ADDENDUM NO. 1
CLASSROOM ADDITION TO ELVIN HILL ELEMENTARY SCHOOL
Architect Job No. 25-34
December 2, 2025
DCM #2025854

The Plans and Specifications are hereby amended. The following supersedes all contrary and/or conflicting information and is made part of the contract documents.

SHEET TITLE:
MECHANICAL SCHEDULES

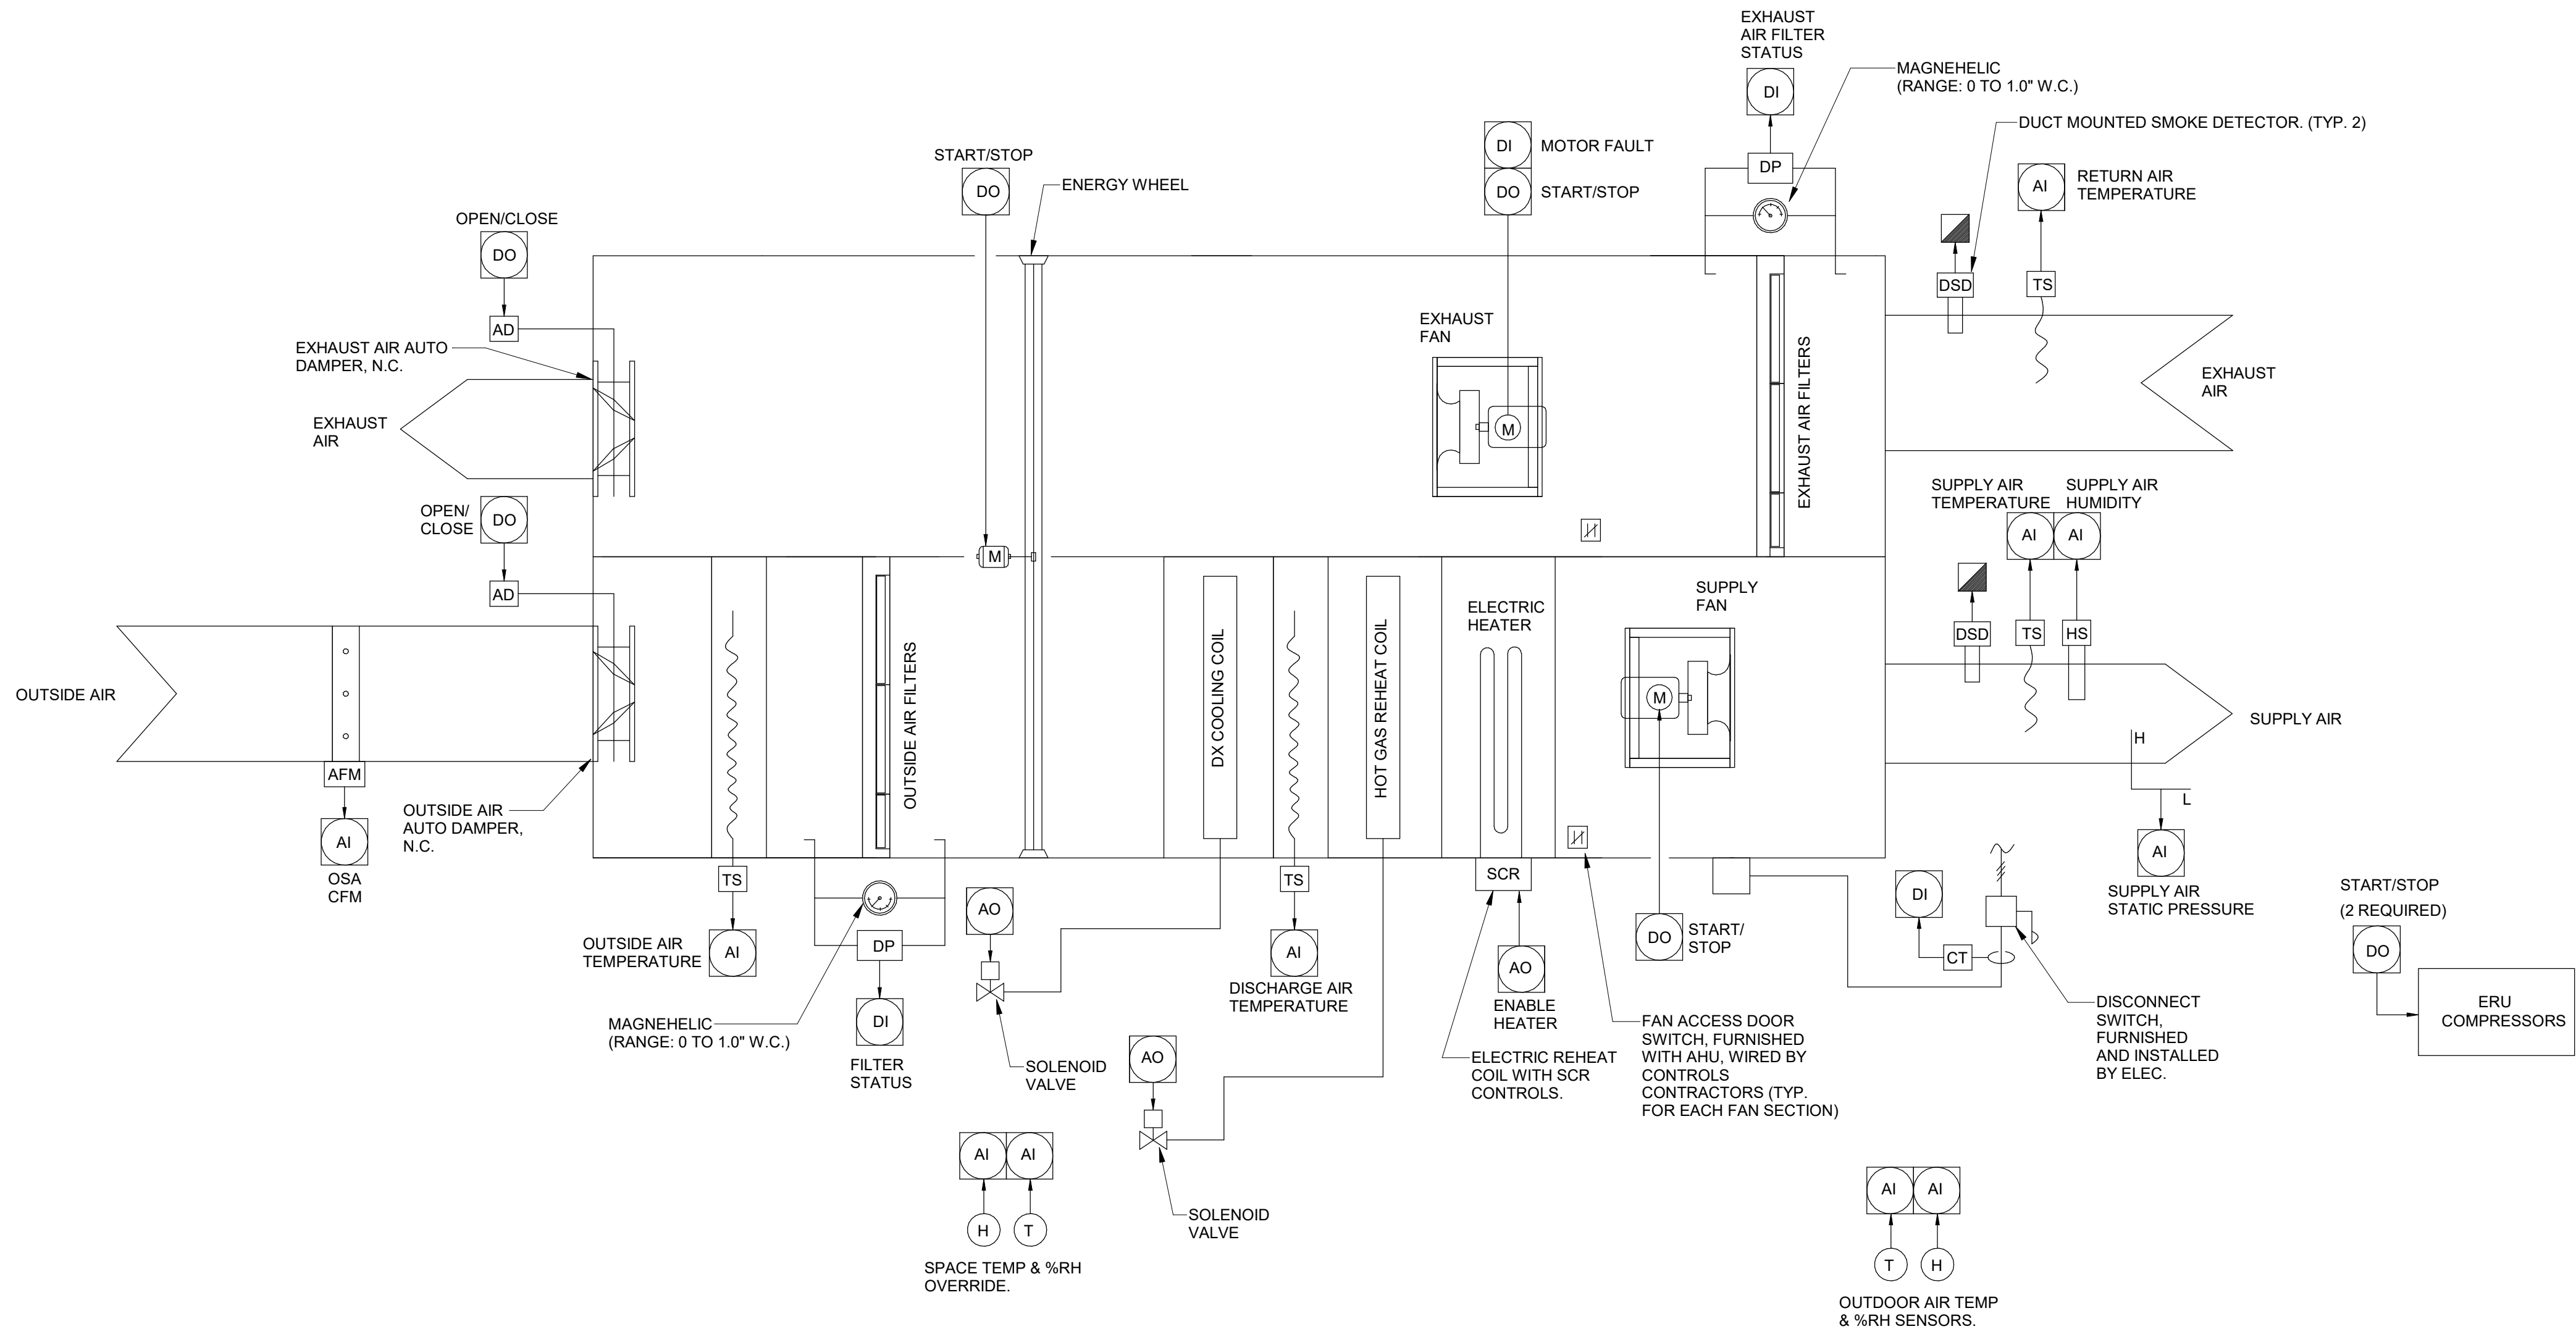
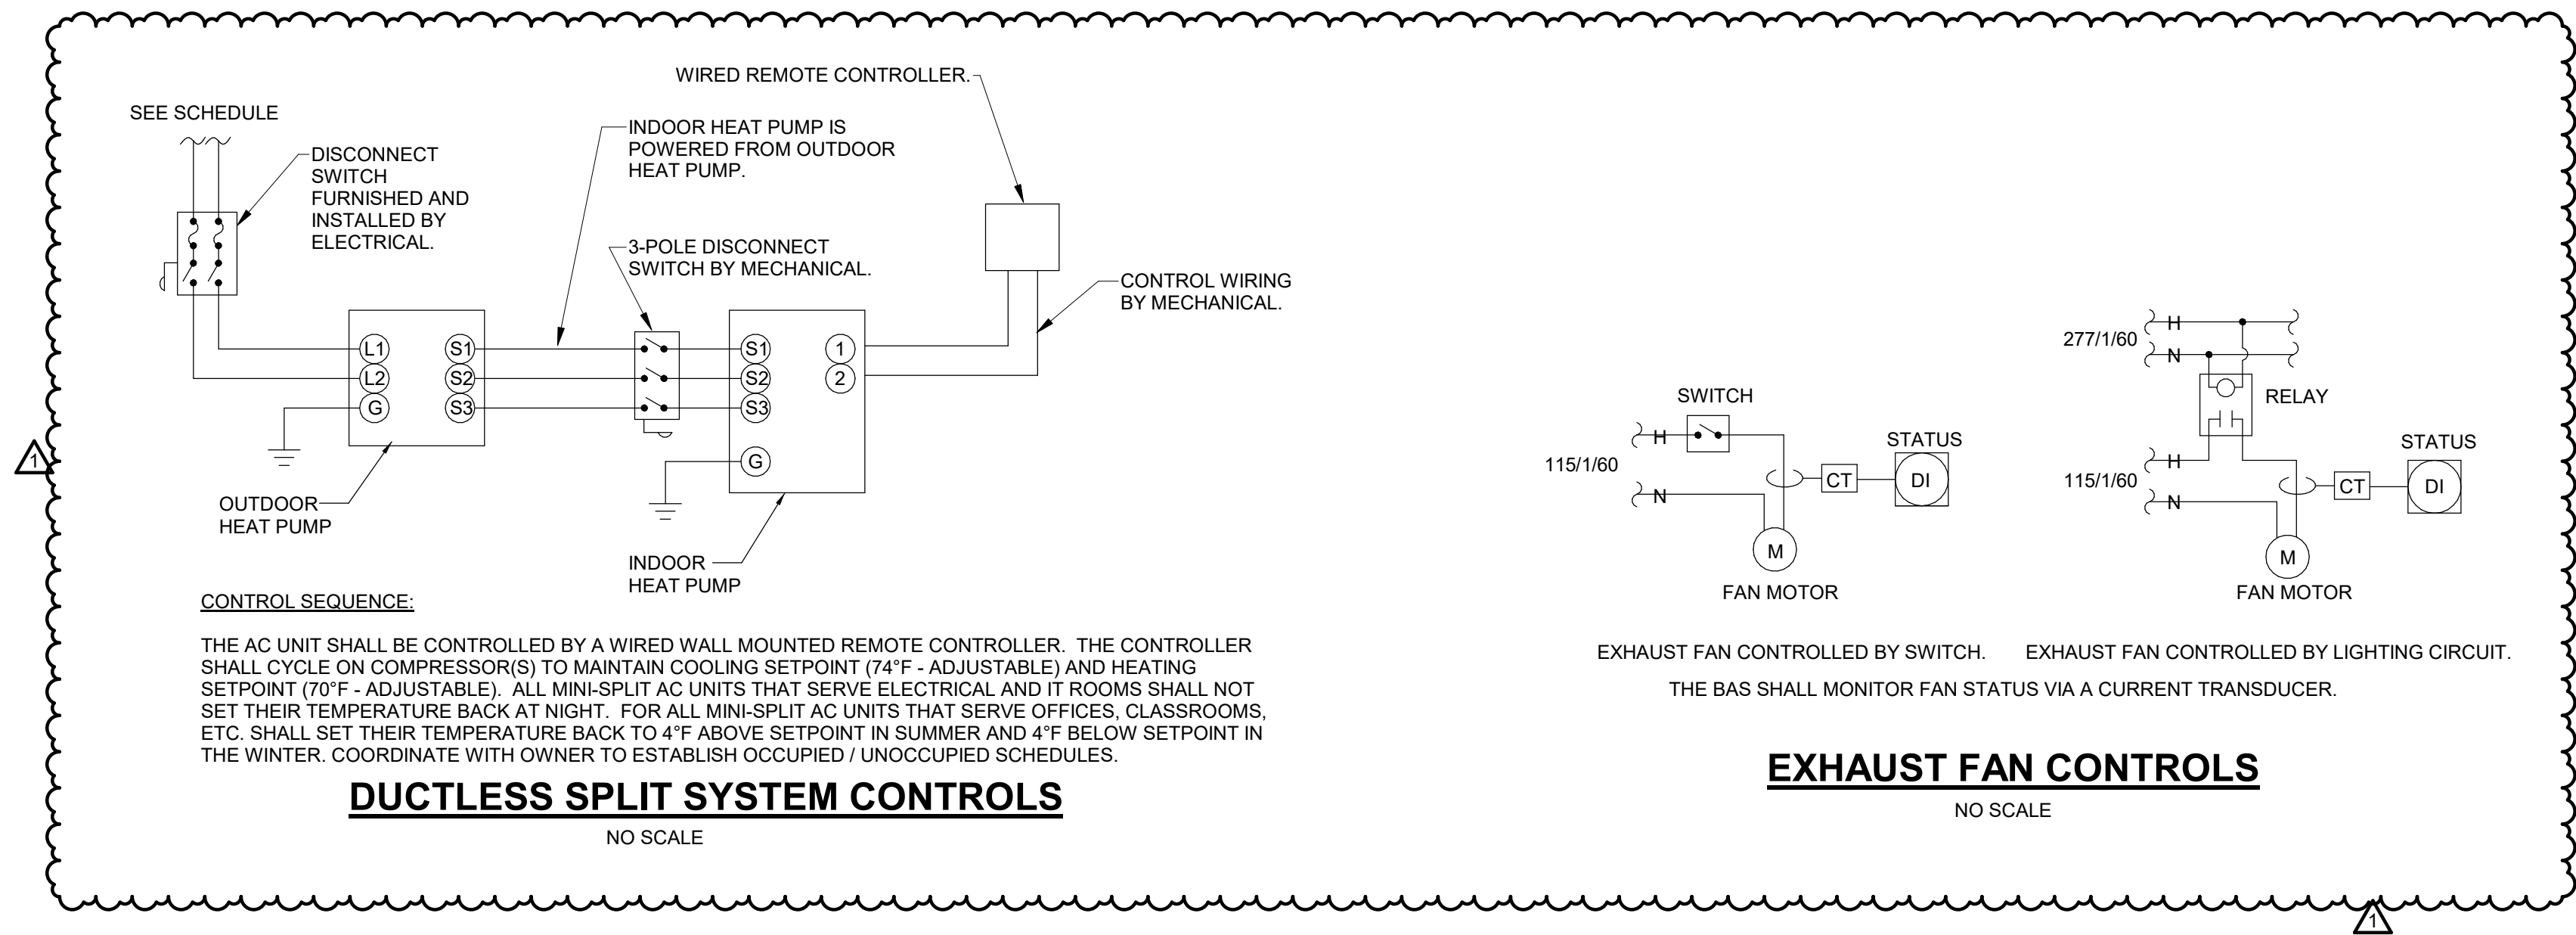
1. **Sheet A2.0.1** – Floor Plan Additional Alternate: See clouded for revisions.
2. **Sheet A10.0** – Plans and Details – Berm Removal & New Brick Facade: See clouded for revisions.
3. **Sheet M0.2** – Mechanical Schedules: See clouded for revisions.
4. **Sheet M0.5** – Mechanical Calculations and Controls: See clouded for revisions.
5. **Sheet M0.6** – Mechanical Controls: See clouded for revisions.
